State of Alaska  
Department of Transportation & Public Facilities

**ENVIRONMENTAL RE-EVALUATION FORM  
FOR FEDERAL HIGHWAY ADMINISTRATION PROJECTS**

Project Name: Kotzebue to Cape Blossom Road  
Project Number (state/federal): Z768840000/NCPD-0002(204)  
Date: 05/25/2017

FIGURE 4

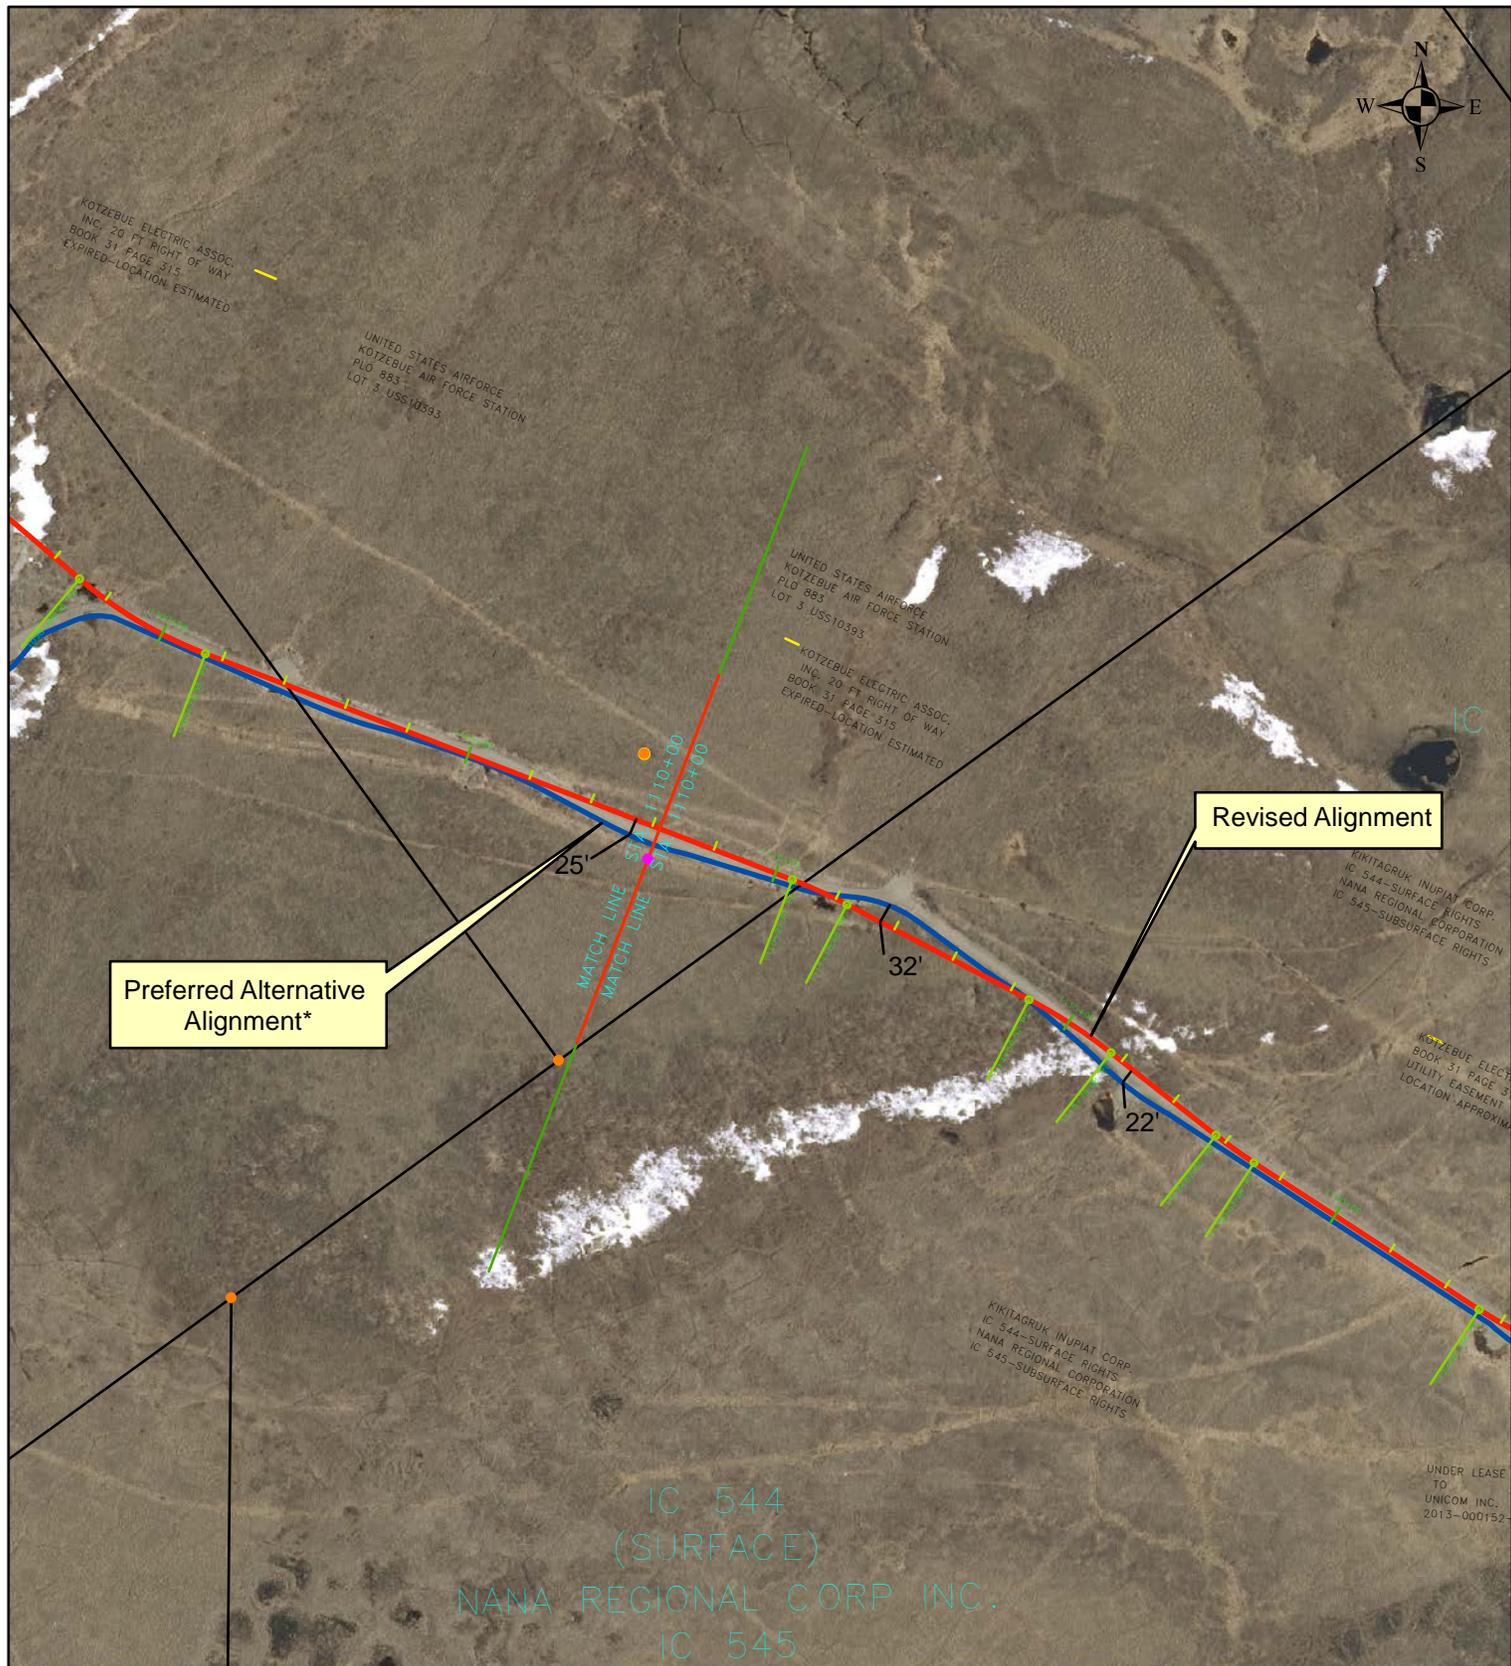
**Changes to the Proposed Action Subsequent to the 12/2013 EA/FONSI:** Minor design changes to road alignment and embankment geometry were made at several locations (Figures 2-6) to avoid the need to place fill in coastal wetlands which was not foreseeable during preliminary design, and to eliminate curves with radii that do not meet AASHTO guidelines. Additionally, subsequent to the

Kotzebue to Cape Blossom Road  
Project APE  
March 2017  
FIGURE 2

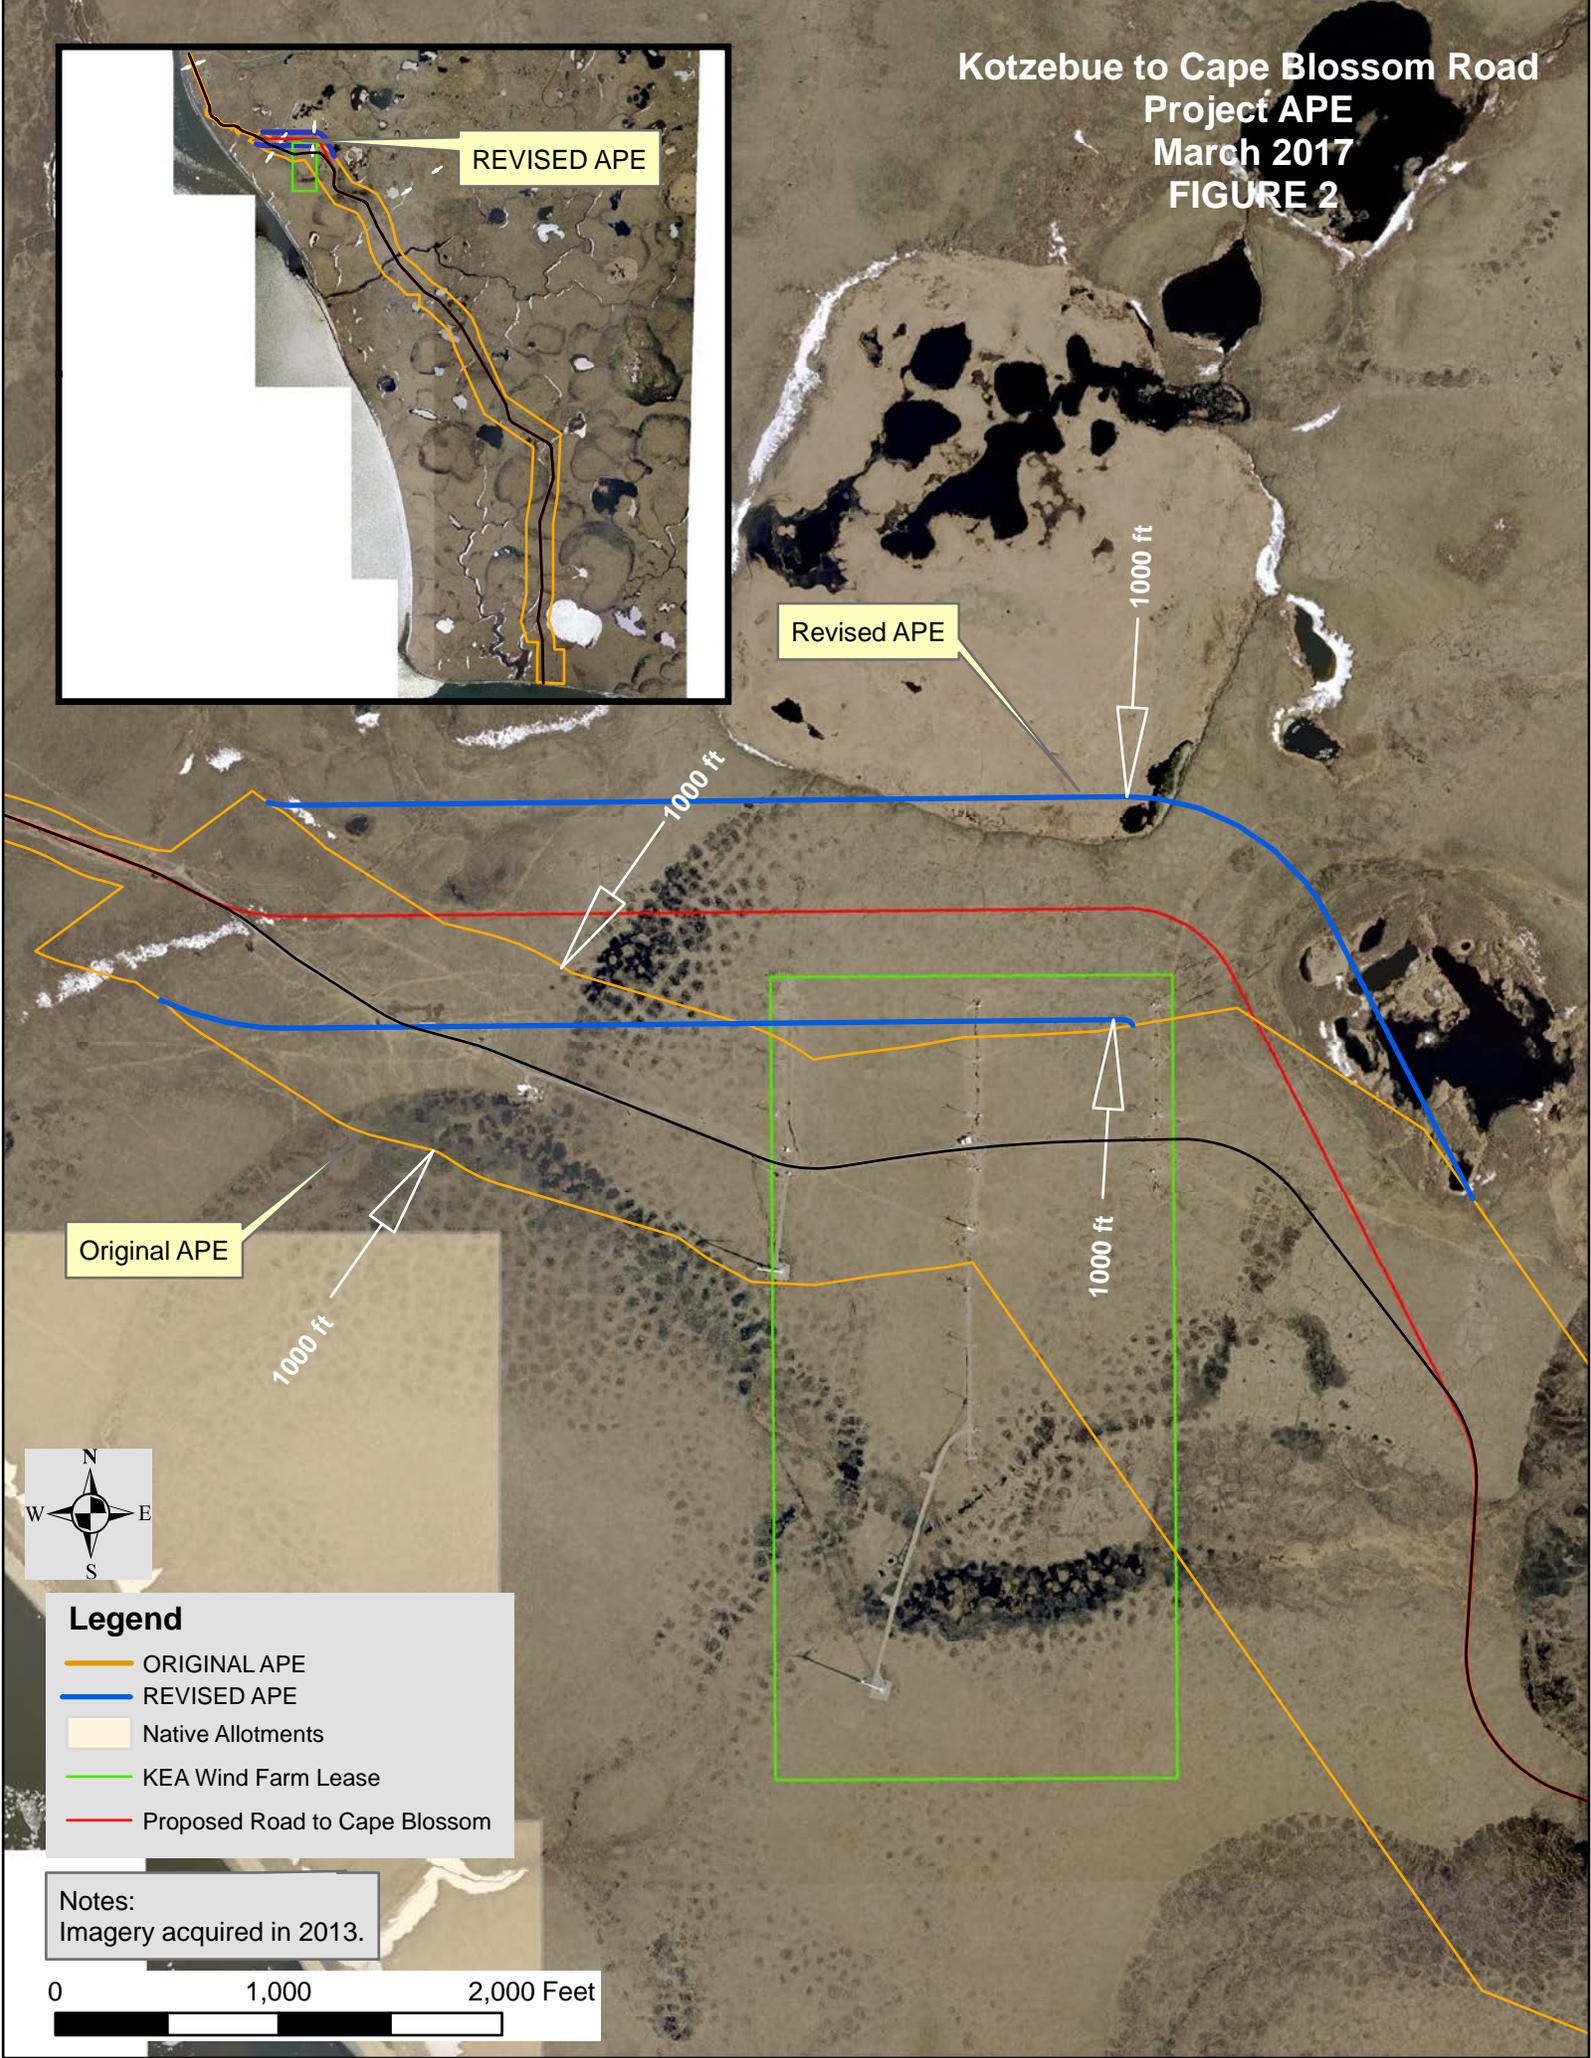
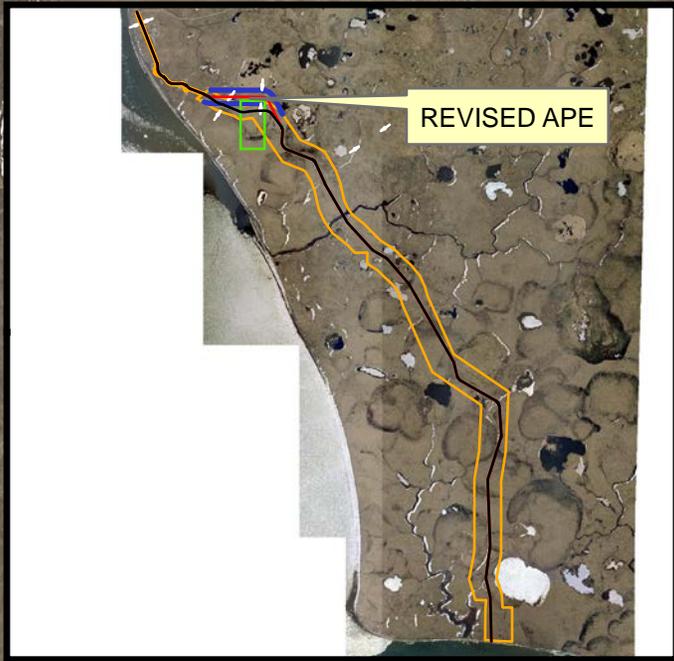
DOT&PF is proposing to revise the approved alignment design and sufficiently avoid the KEA wind farm to eliminate potential wind turbine ice throw. The revised route would deviate from the existing KEA access road at a point approximately 2500-ft northwest of the windfarm, and from that point extend eastward paralleling the northern boundary of the wind farm property for 4000 feet before bearing southeasterly to tie back into the approved preferred route alternative approximately 2300 feet southeast of the wind farm (Figure 2). The remainder of the project APE is unchanged.

Kotzebue to Cape Blossom Road  
Project APE  
March 2017  
FIGURE 2

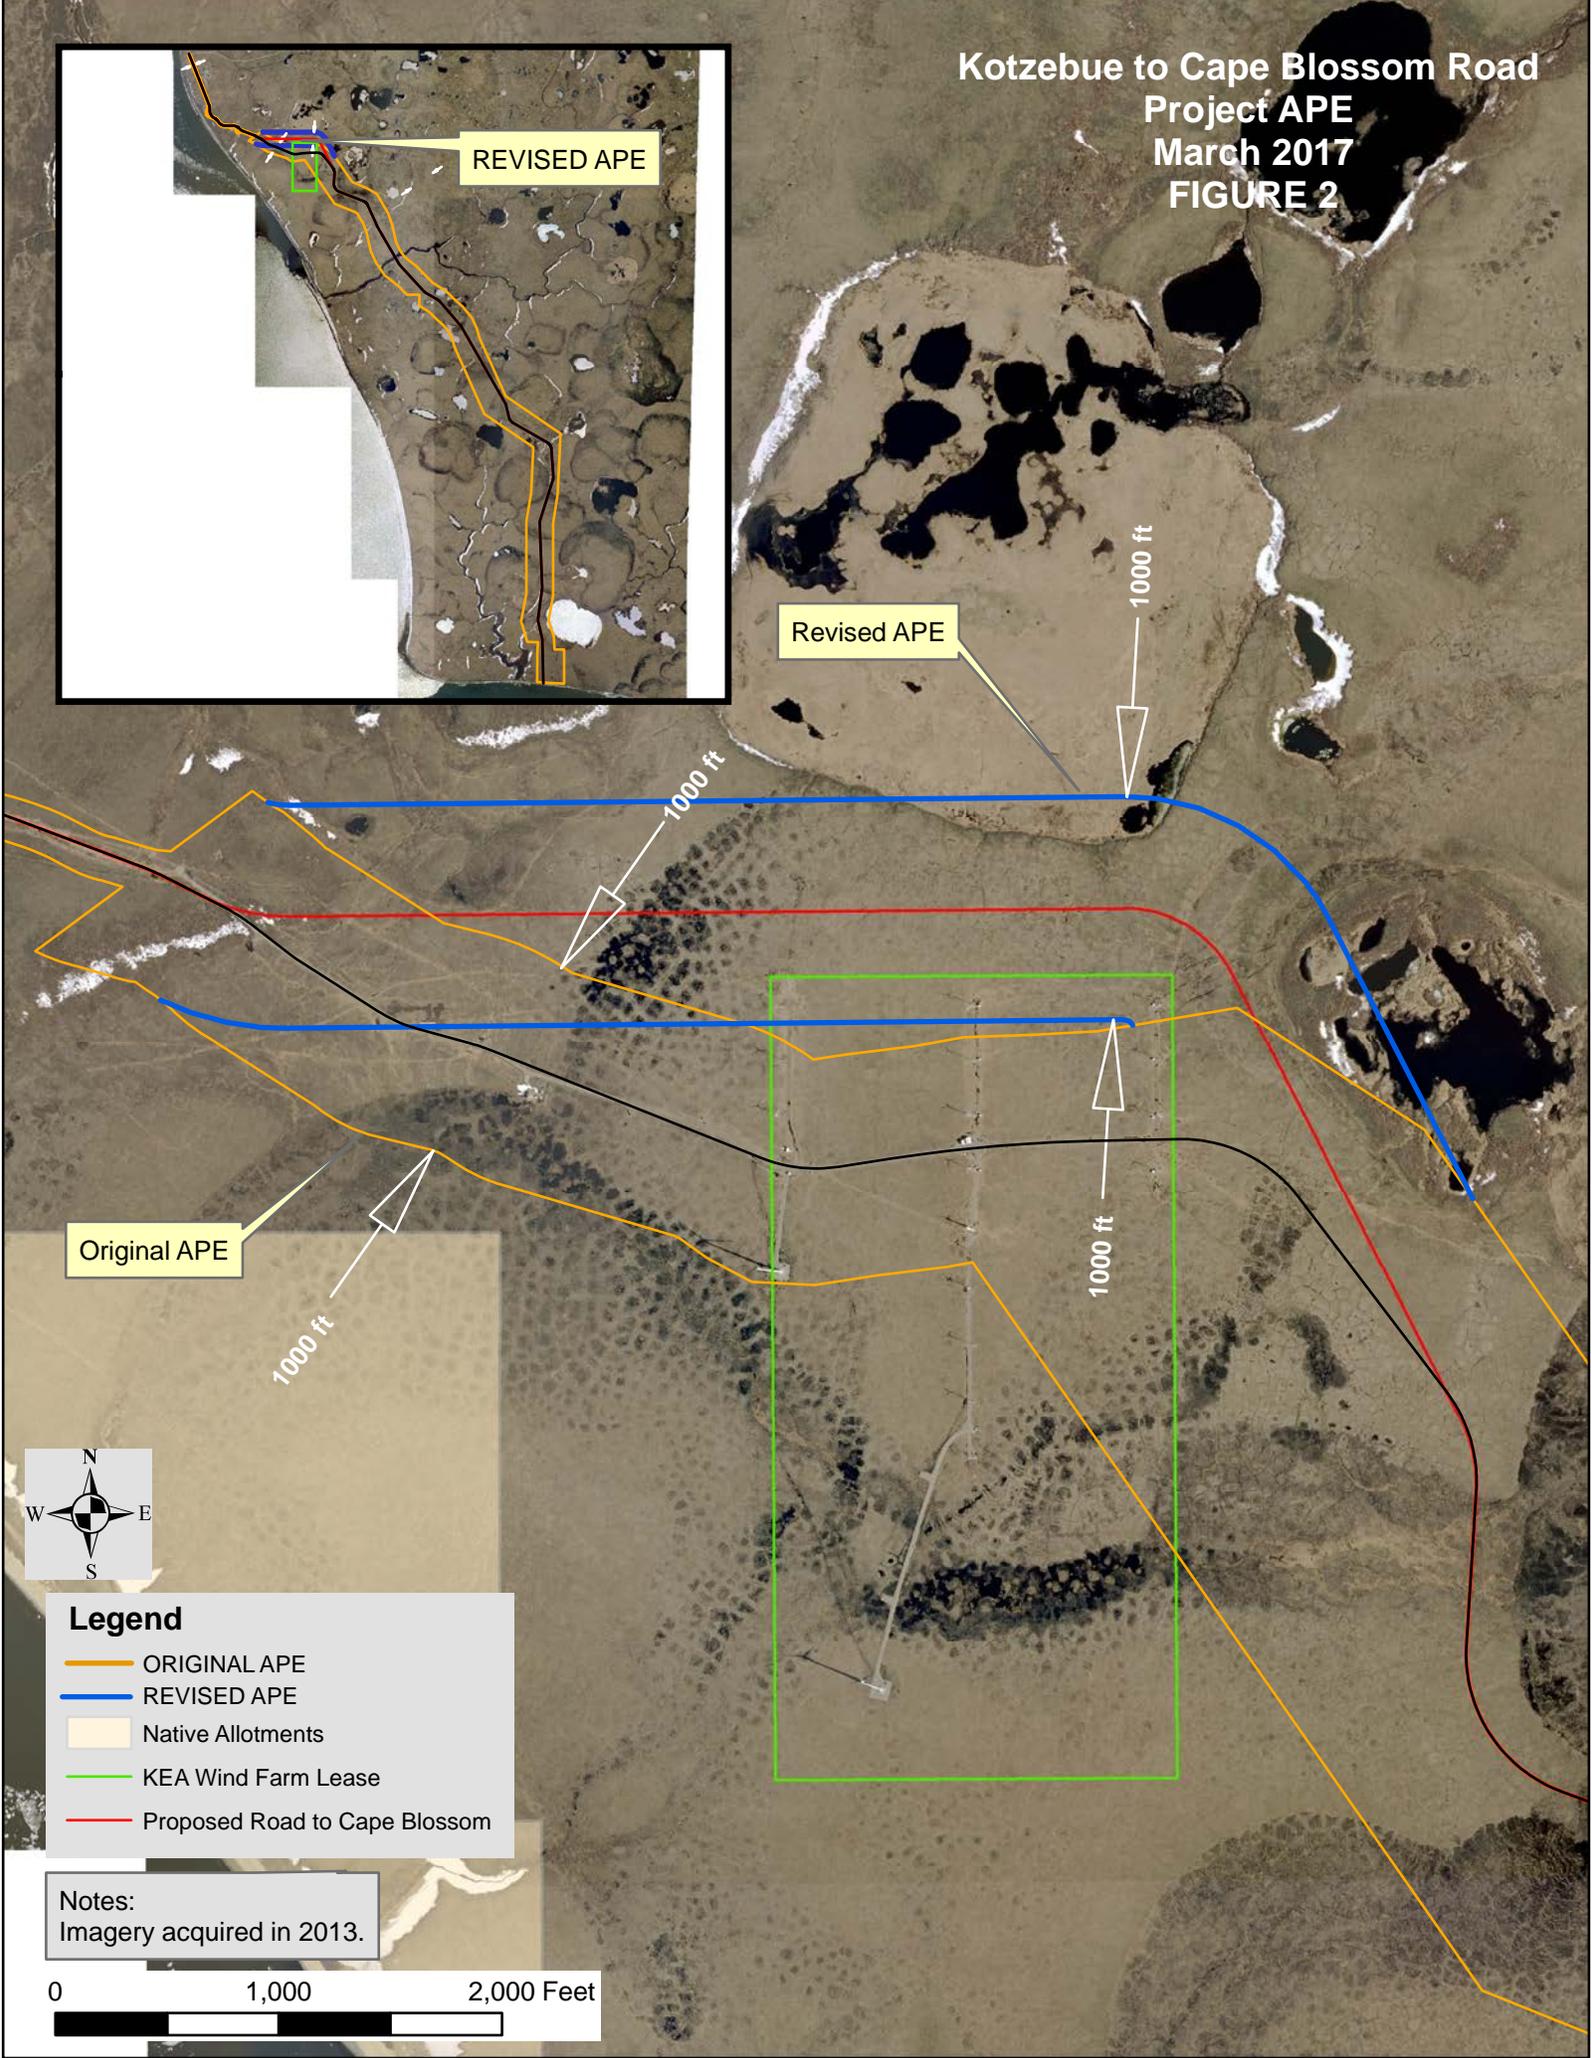
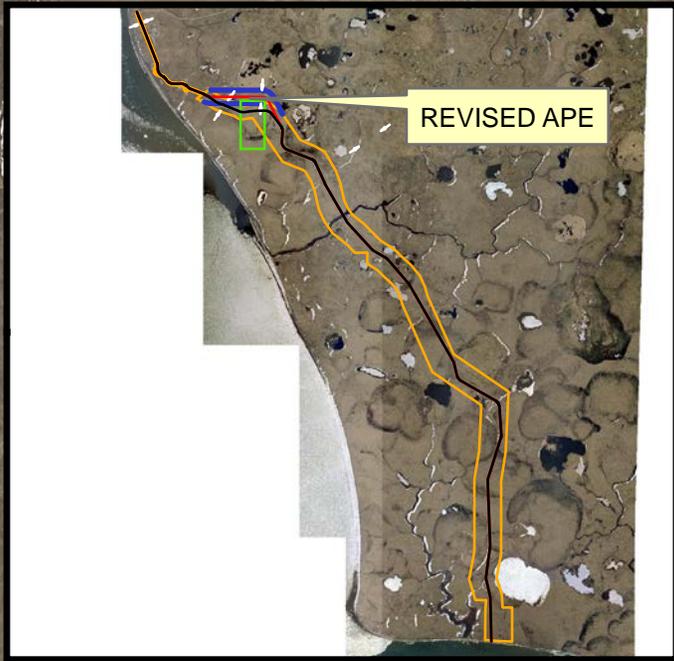
DOT&PF is proposing to revise the approved alignment design and sufficiently avoid the KEA wind farm to eliminate potential wind turbine ice throw. The revised route would deviate from the existing KEA access road at a point approximately 2500-ft northwest of the windfarm, and from that point extend eastward paralleling the northern boundary of the wind farm property for 4000 feet before bearing southeasterly to tie back into the approved preferred route alternative approximately 2300 feet southeast of the wind farm (Figure 2). The remainder of the project APE is unchanged.
